May 26, 2017

TO : All Bidders
FROM : George M. Wiens
PROJECT : CTE Classroom Addition
1615400.41
SUBJECT : Addendum 1
DSA : 04-115755 / 33-H18

NTS 4

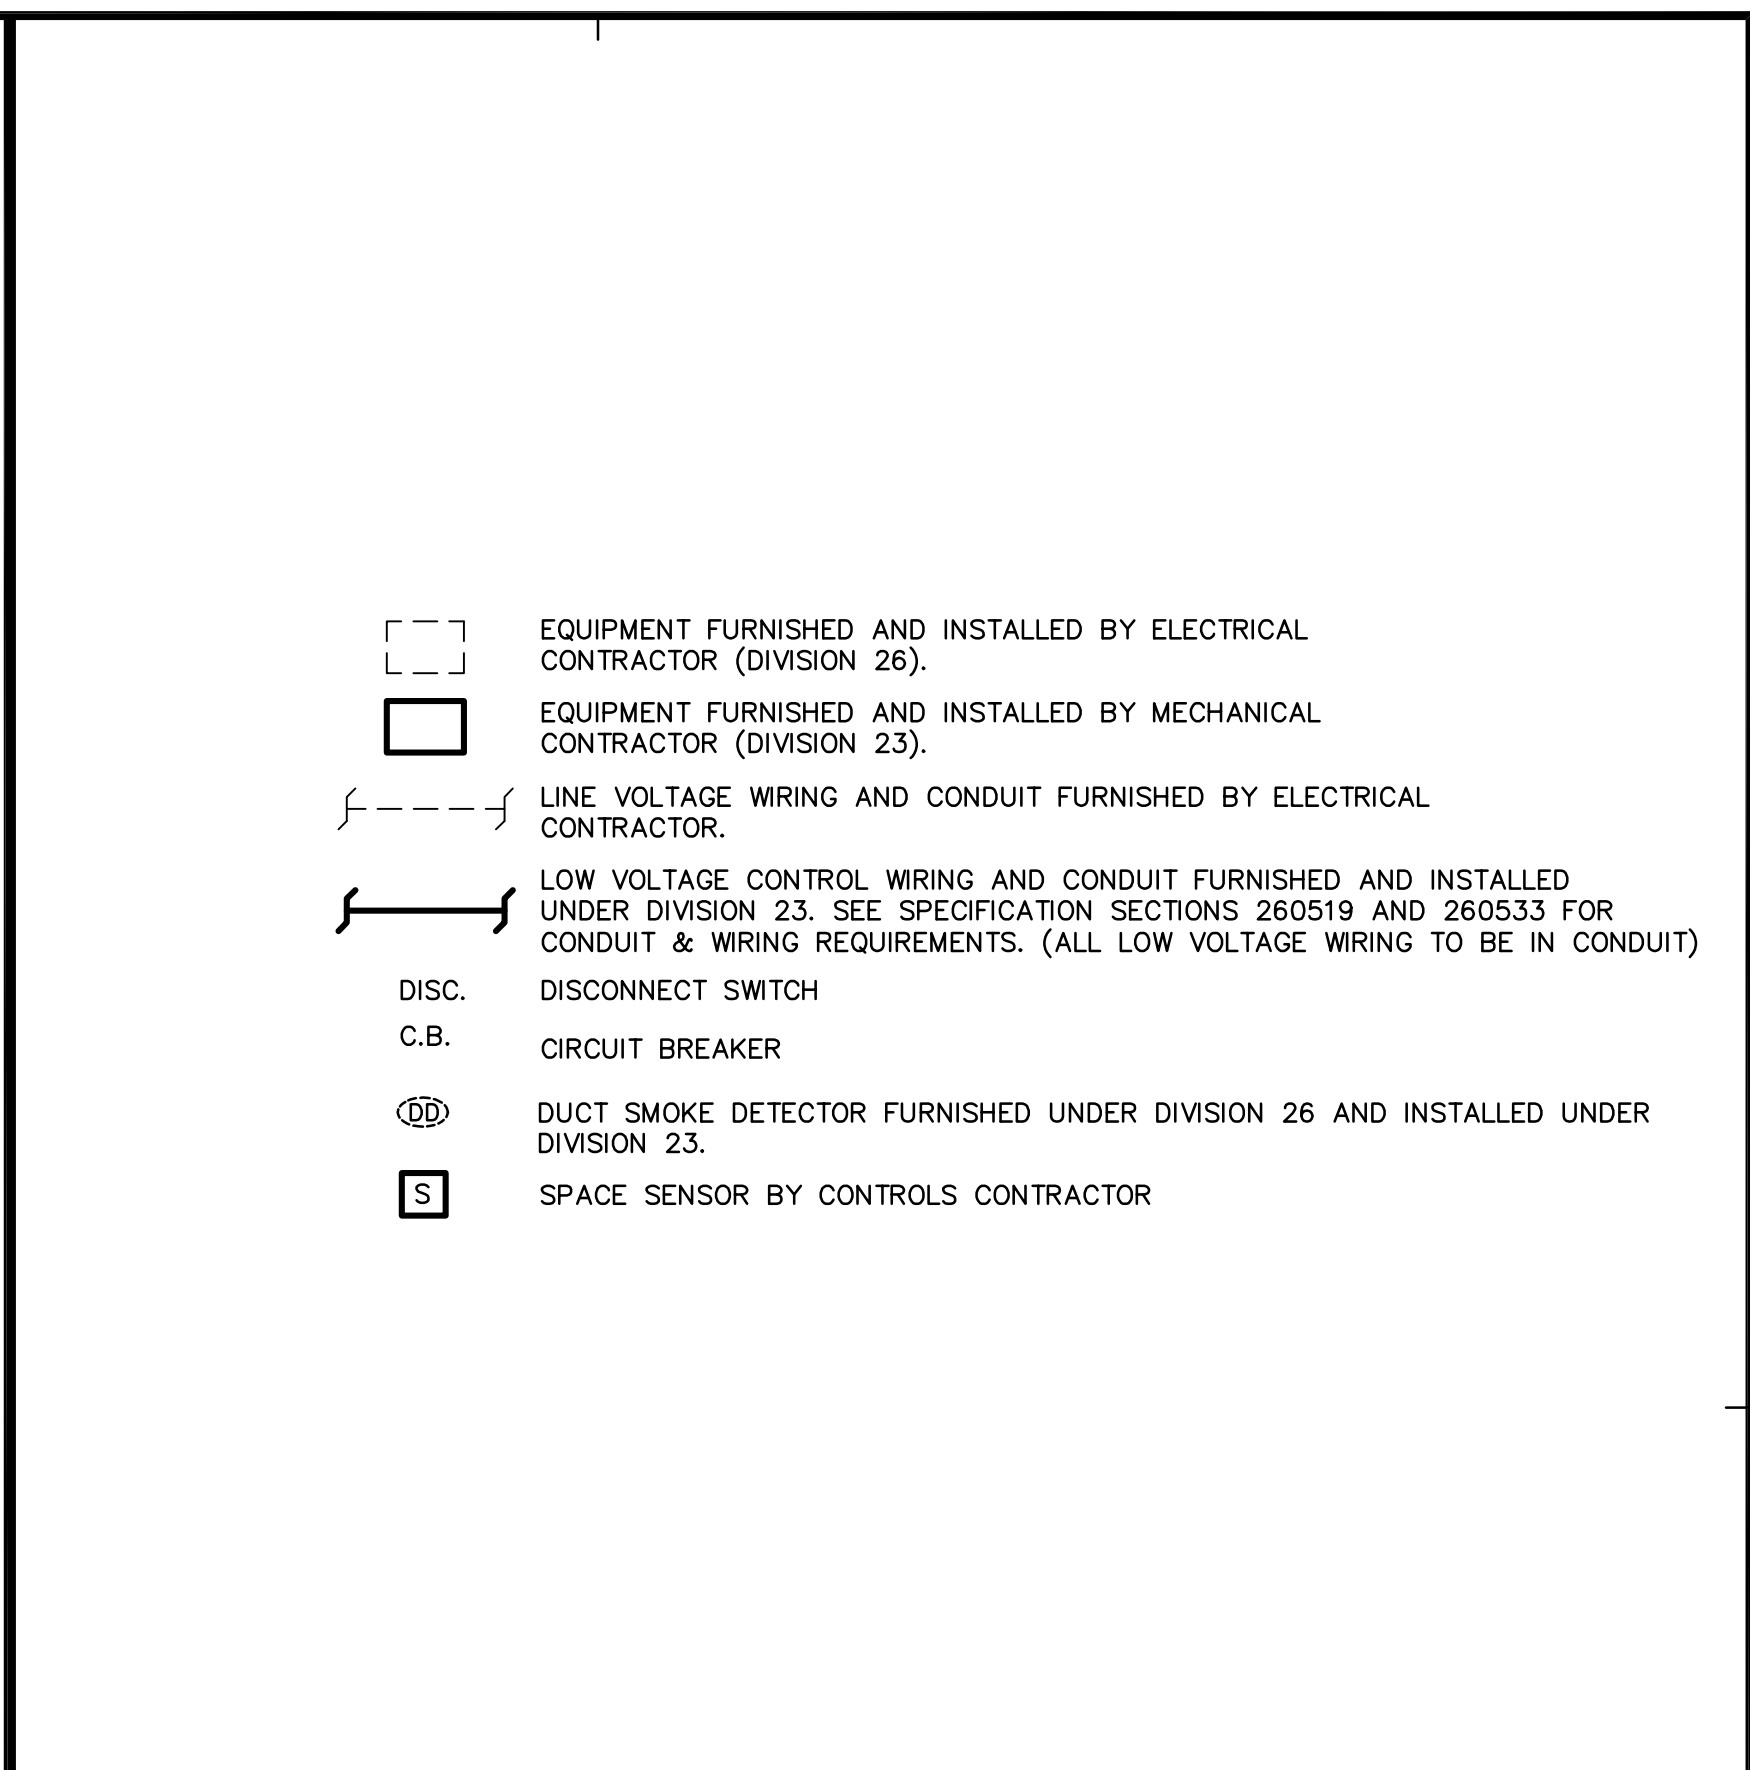
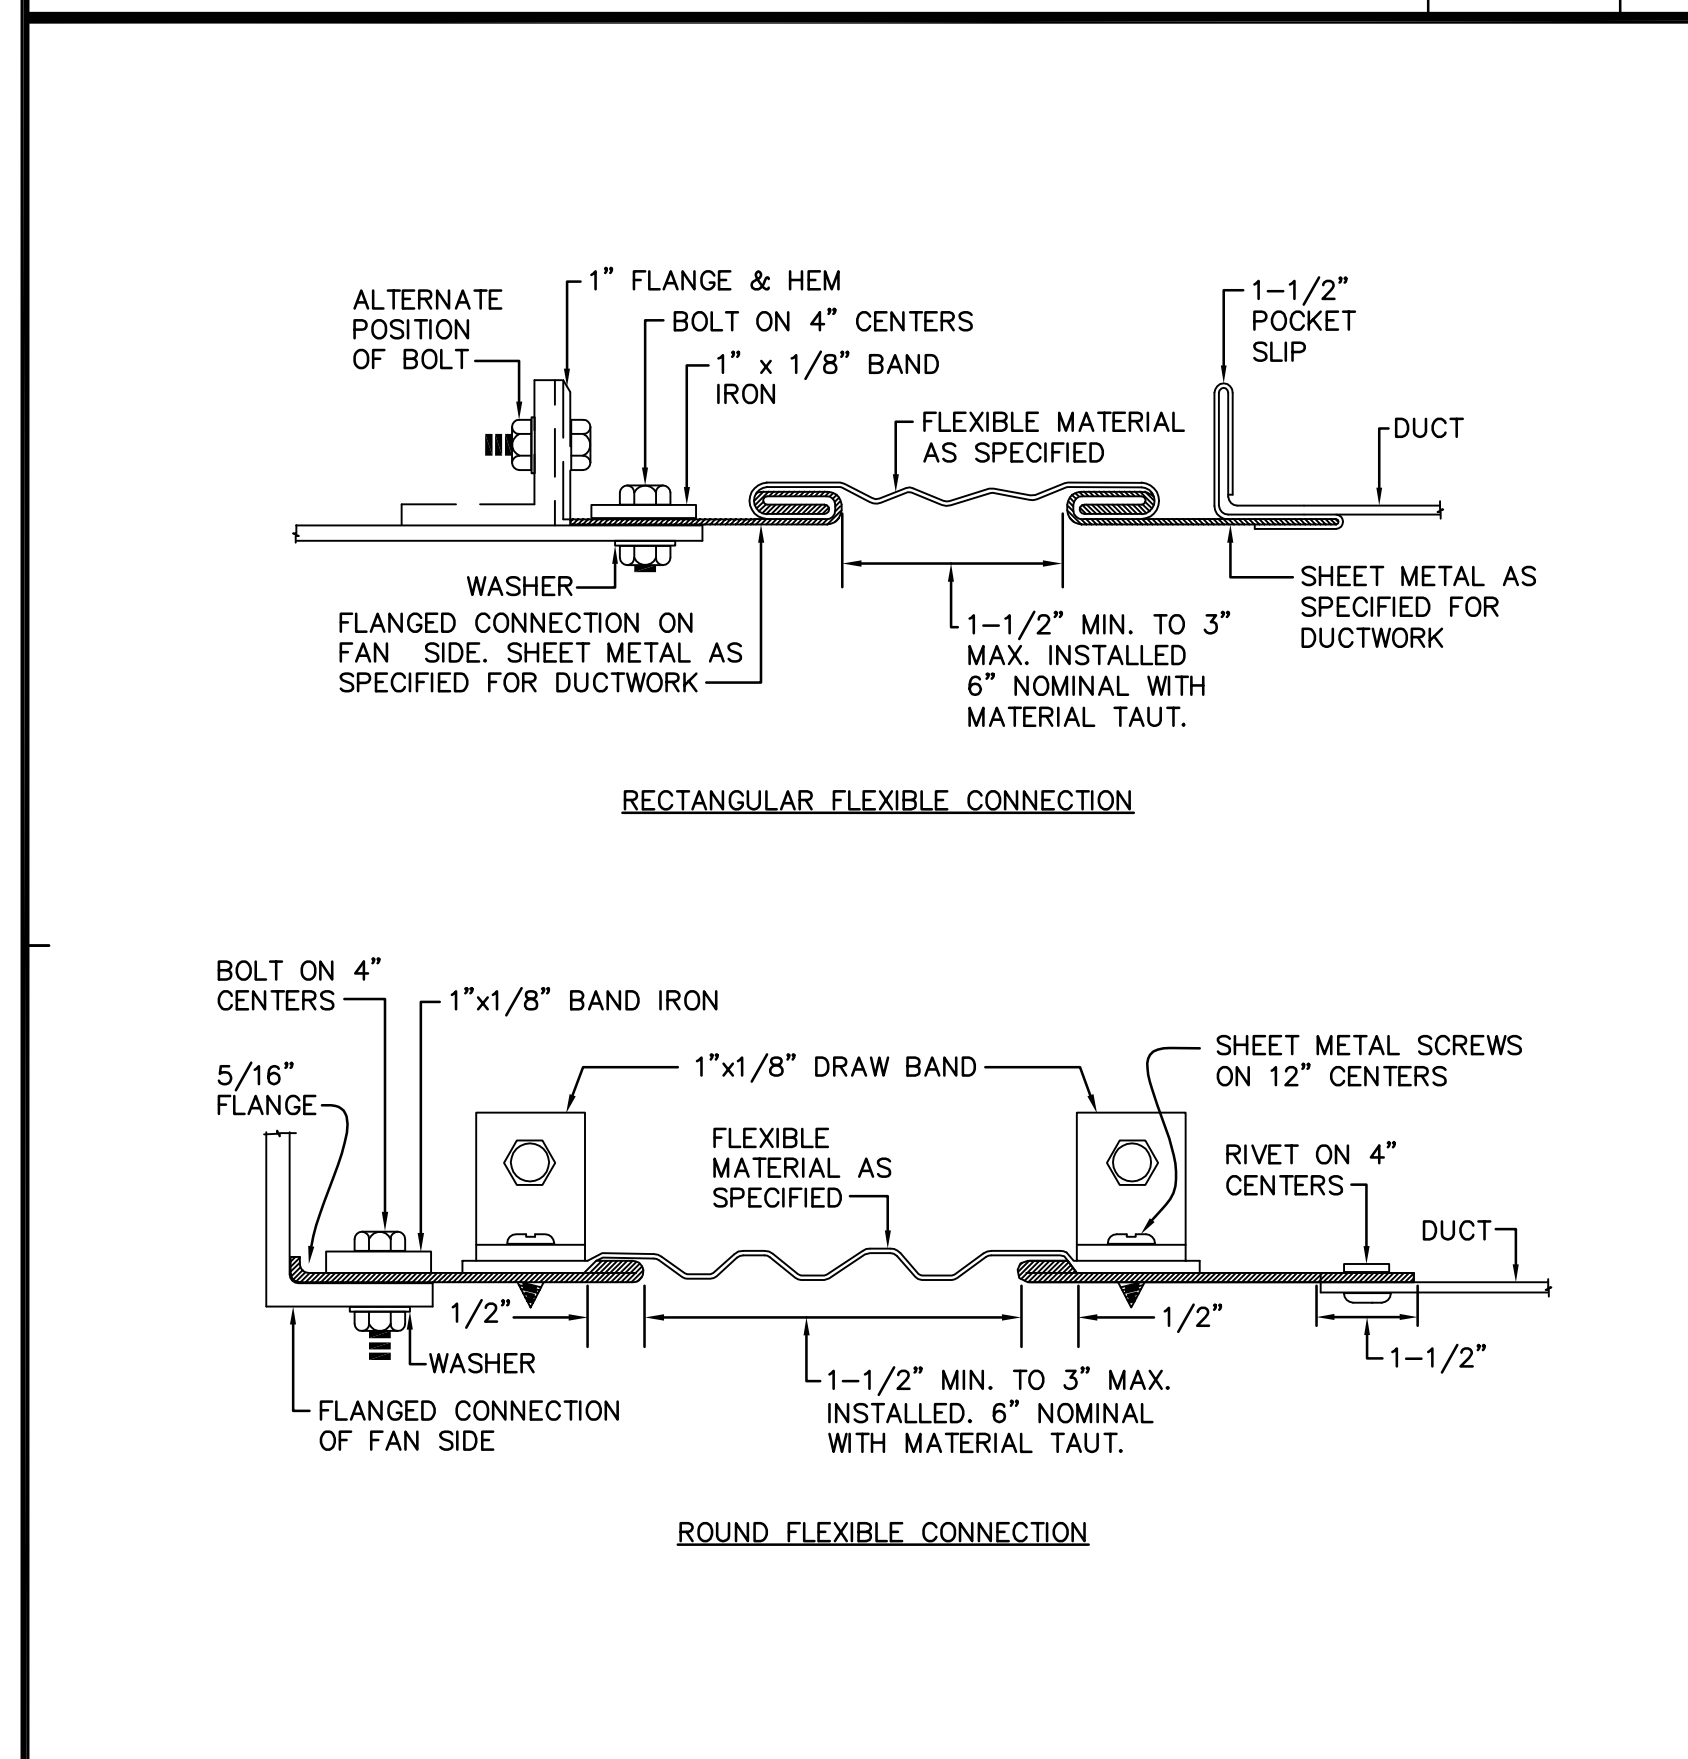
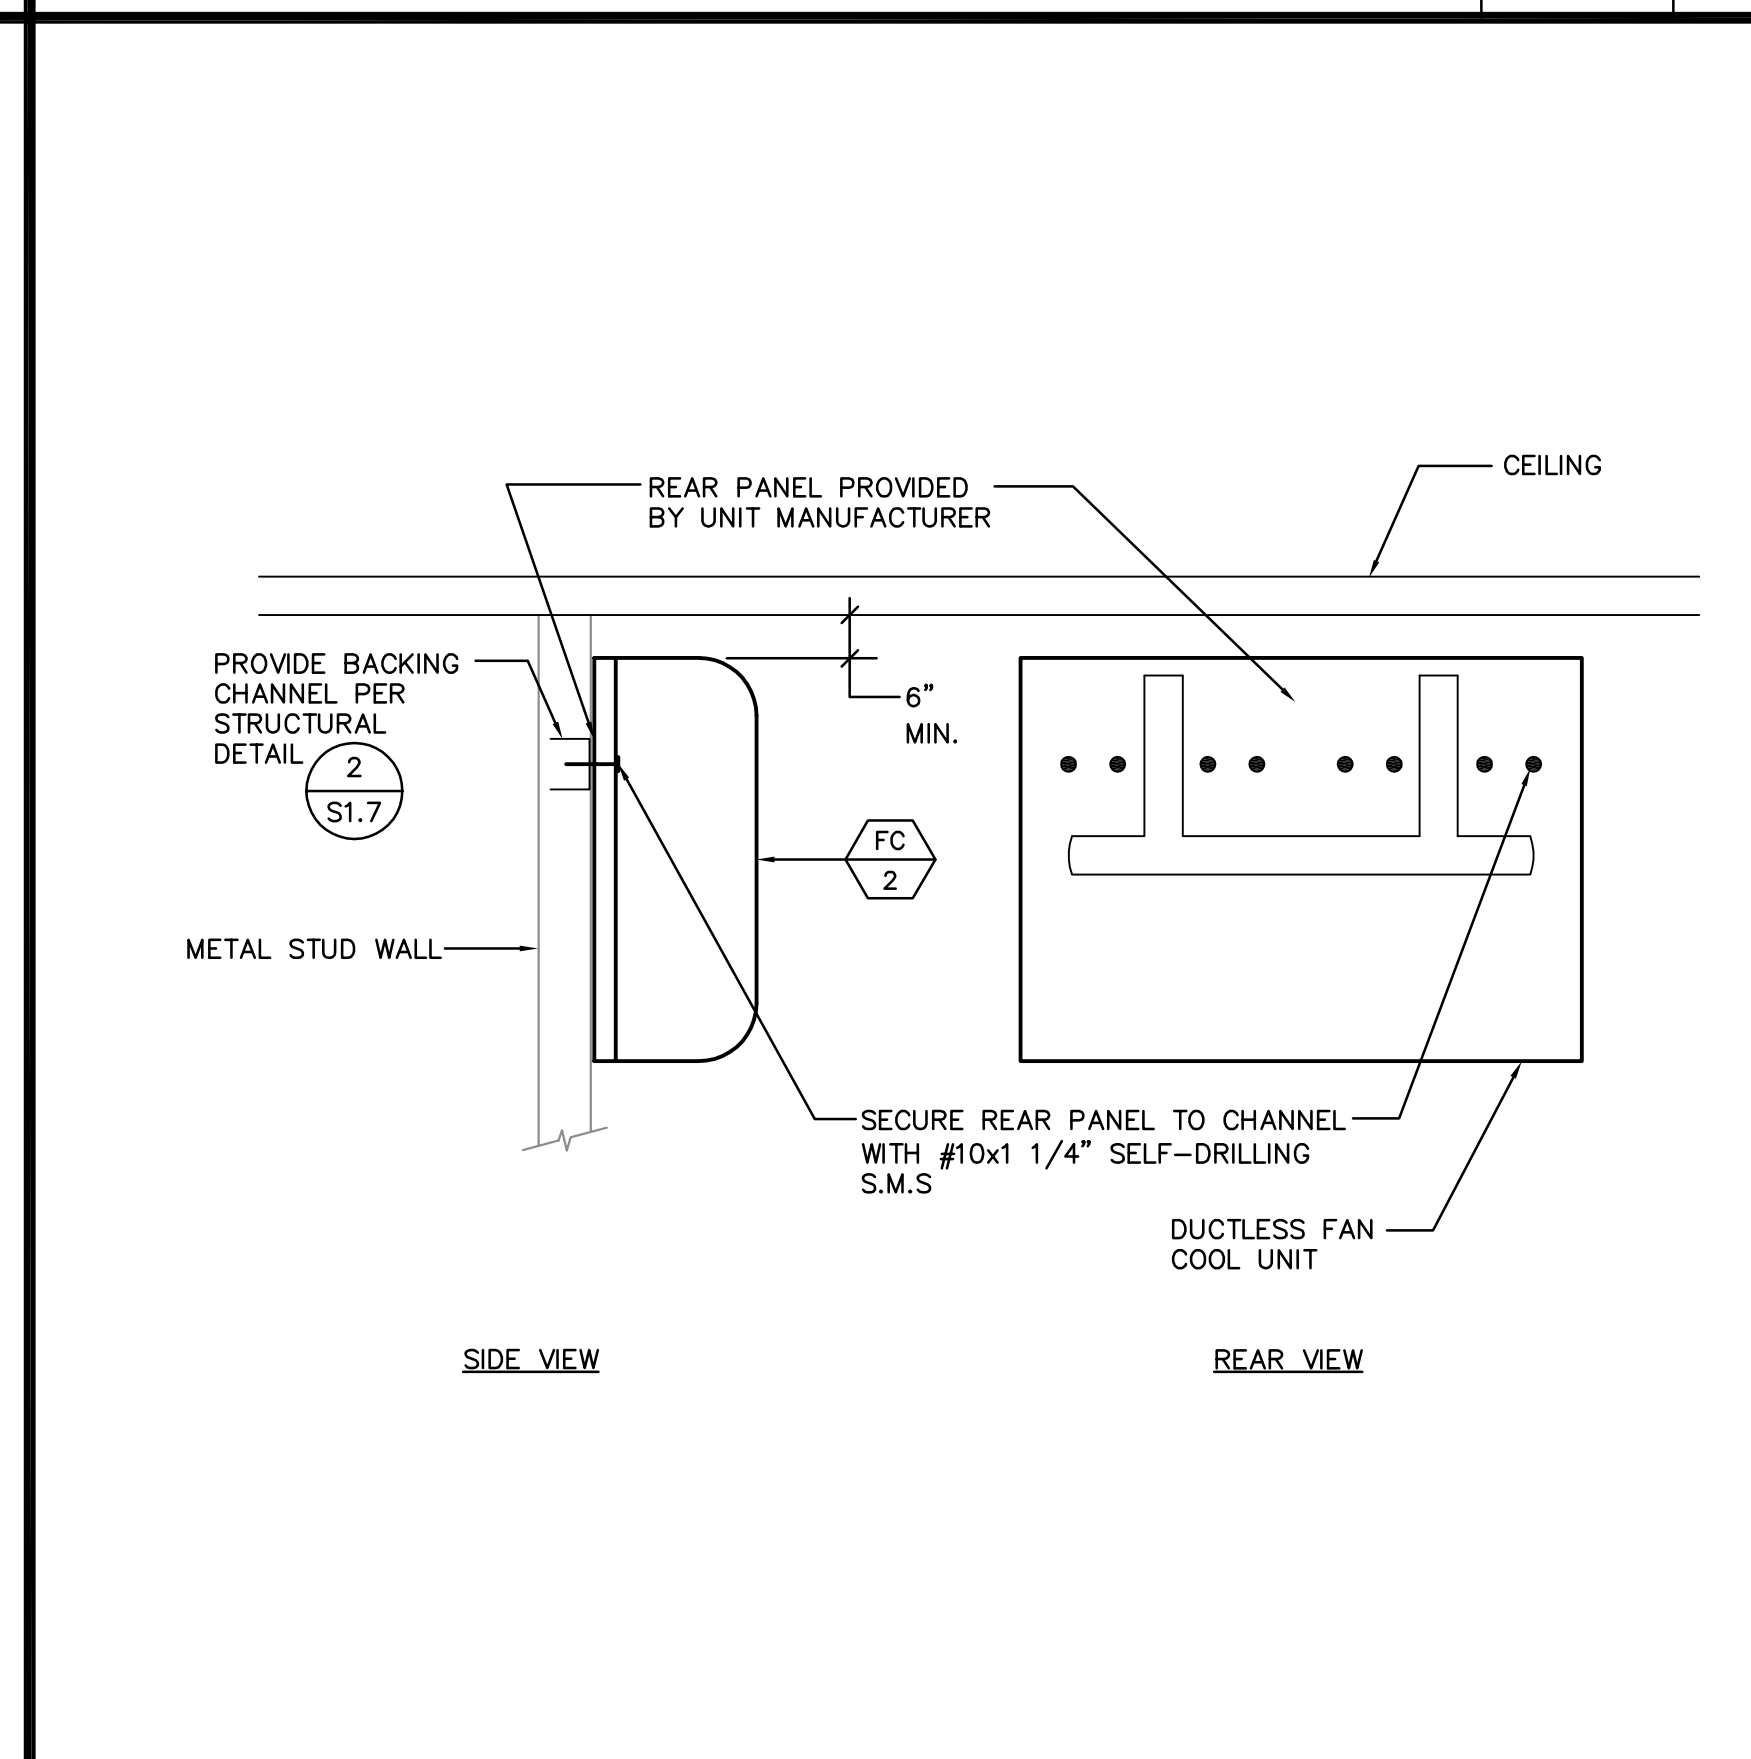
- A. Revise as indicated in the clouded area labeled Delta 1 on the attached M4.2.
